EPA Superfund
Record of Decision:

**Commencement Bay Nearshore/
Tideflats (O.U. 2), Tacoma, WA**
3/24/1995

RECORD OF DECISION

**ASARCO TACOMA SMELTER FACILITY
RUSTON AND TACOMA, WASHINGTON**

FIGURE 7-2: HAZARDOUS WASTE ON-SITE CONTAINMENT FACILITY (OCF)

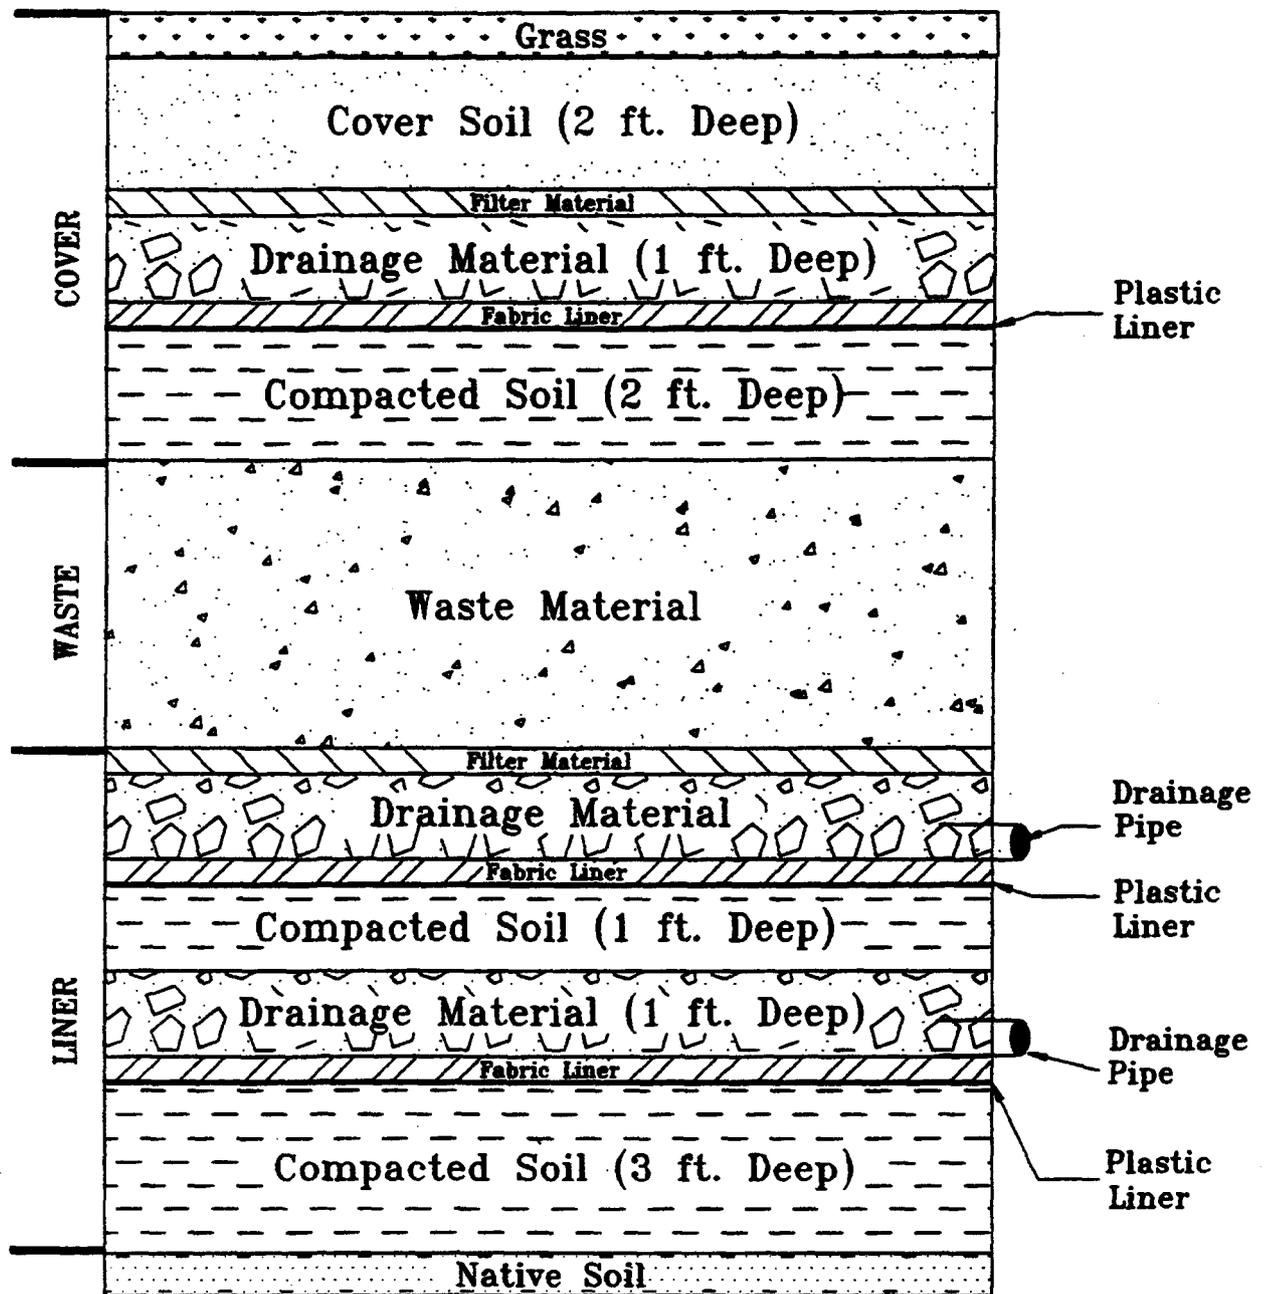
28. **COMMENT: Page 16, Figure 3 (in Proposed Plan), Hazardous Waste On-Site Containment Facility (OCF).** The figure is not correct. The part of the cover that includes a 1 foot layer, which underlies the filter material, would not consist of compacted soil as shown in the figure but, instead, would consist of a drainage layer.

RESPONSE: In the cap, beneath the one foot of drainage material, there will be a fabric liner and two feet of compacted soil above the waste material, see Figure 7-2.
